The Commission has issued the enclosed Amendment Nos. 15 and 11 to Facility License Nos. DPR-29 and DPR-50 for Units 1 and 2 of the Grand Cities Nuclear Power Station. These amendments include Change No. 26 to the Technical Specifications and is in response to Commonwealth Edison's request dated December 15, 1974, as supplemented December 20, 1974; January 27, 1975; March 14 and 27, 1975, and April 9, 1975. These amendments also include your request dated May 15, 1974, as supplemented by filings dated October 22 and December 5, 1974.

These amendments (1) incorporate operating limits in the Technical Specifications based on the new General Electric Thermal Analysis Basis (GTAB), and (2) authorize changes to the APRM flux screen and APRM Rod Block Limits.

QUAD CITIES NUCLEAR POWER STATION UNIT 1

ATTACHMENT TO LICENSE AMENDMENT NOS. 11 AND 15
CHANGE NO. 26 TO THE TECHNICAL SPECIFICATIONS
FACILITY OPERATING LICENSE NOS. DPR-29 AND DPR-30
DOCKET NOS. 50-254 AND 50-265

Figure 2.1-2
 PEAK LHGR VERSUS CORE THERMAL POWER
 FOR A LIMITING TOTAL PEAKING FACTOR

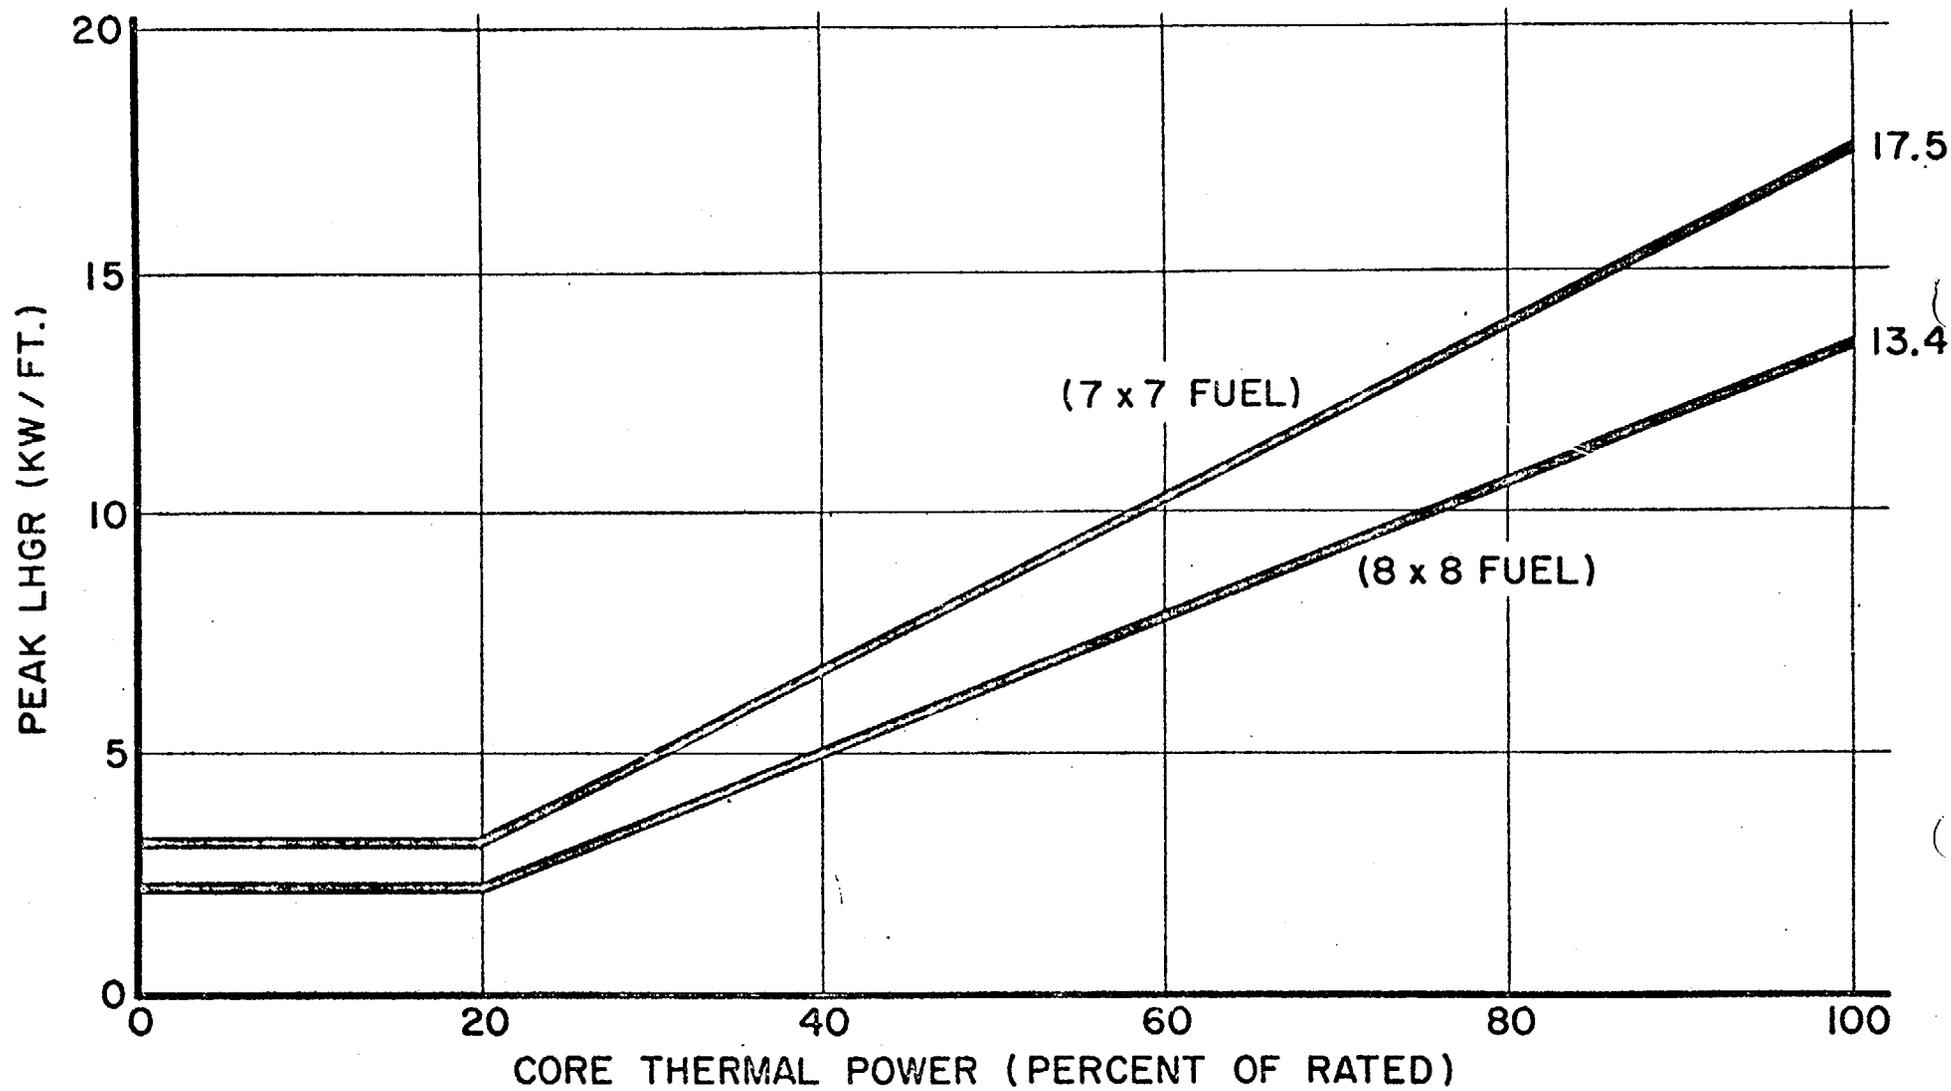
terms of heat flux and base the required settings on the design linear heat generation rates of 17.5 and 13.4 kw/ft for 7 x 7 and 8 x 8 fuel respectively. Figure 2.1.2 would be changed from a linear plot of peak heat flux versus power to a plot of peak LHGR versus power for 7 x 7 and for 8 x 8 fuel. For power levels between zero and 20% of rated core thermal power, peak LHG rates of 3.5 and 2.68 kw/ft rather than total peaking factors are specified for 7 x 7 and for 8 x 8 fuel respectively. Below these LHGR levels fuel cladding damage because of a departure from nucleate boiling would not be expected and therefore these limiting safety system settings are acceptable.

TFP = LTPF unless the combination of power and peak LHGR is above the curve in Figure 2.1-2 at which point the actual peaking factor value shall be used.

FIGURE 2.1-3 APRM FLOW BIAS SCRAM RELATIONSHIP TO NORMAL OPERATING CONDITIONS

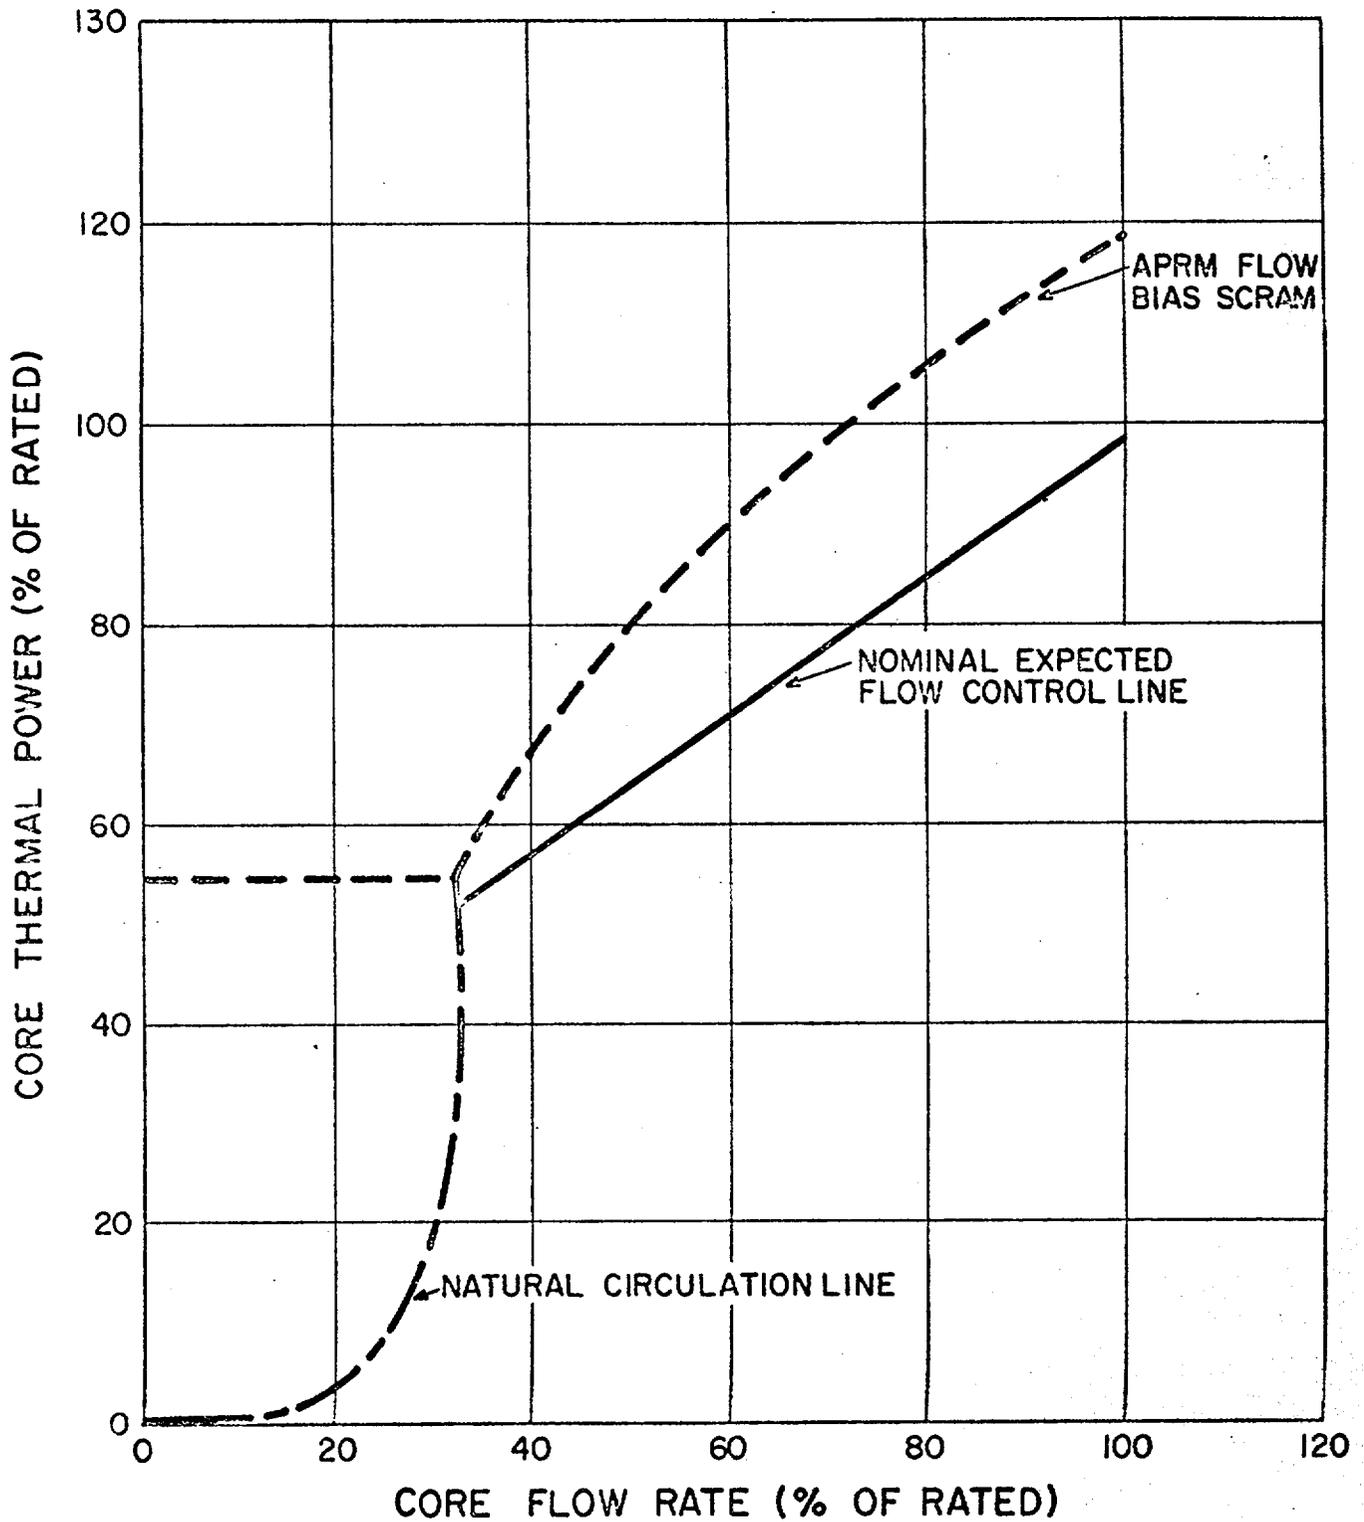
The figures in the technical specifications specifying the limiting safety system settings for APRM flux scram and APRM rod block (Figure 2.1.1) are based on calculations using specified ratios of local to average power. If the actual ratios are higher than the value specified in the reference calculations, the limits are lowered. The way in which these limits are corrected and lowered during operations with high peaking factors is specified by use of Figure 2.1-2 and by the equations in Section 2.1.A.1 and Section 2.1.B of the technical specifications. The corrections are presently stated in terms of peak heat flux and are calculated for 7 x 7 fuel. To clearly state the appropriate correction for 8 x 8 fuel, as well as 7 x 7 fuel, CE has proposed to state the correction in terms of total peaking factors as compared to reference (limiting) total peaking factors. This requires a change in the definition of peaking factor and in the figures and equations which specify the limits.

FIGURE 3.5-2 K_f FACTOR

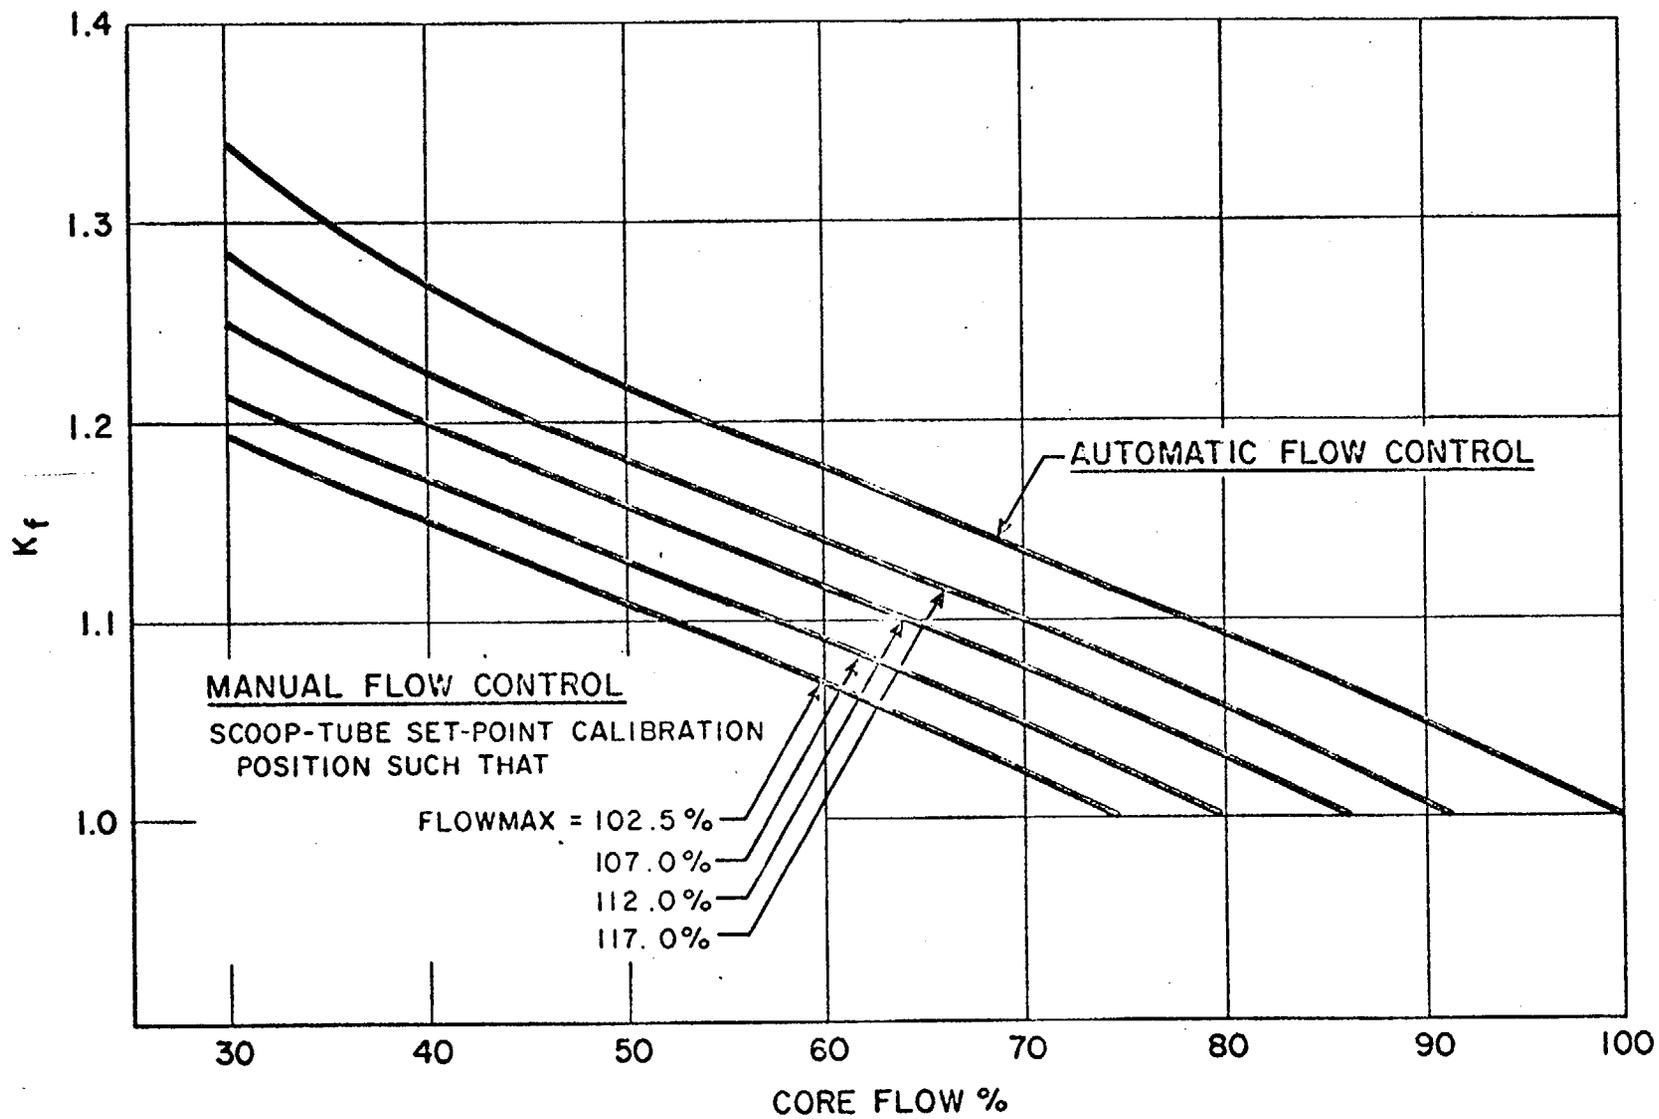
at rated power and flow. For core flows other than rated, these nominal values of MCPR shall be increased by a factor of K_f , where K_f is as shown in Figure 3.5-2.
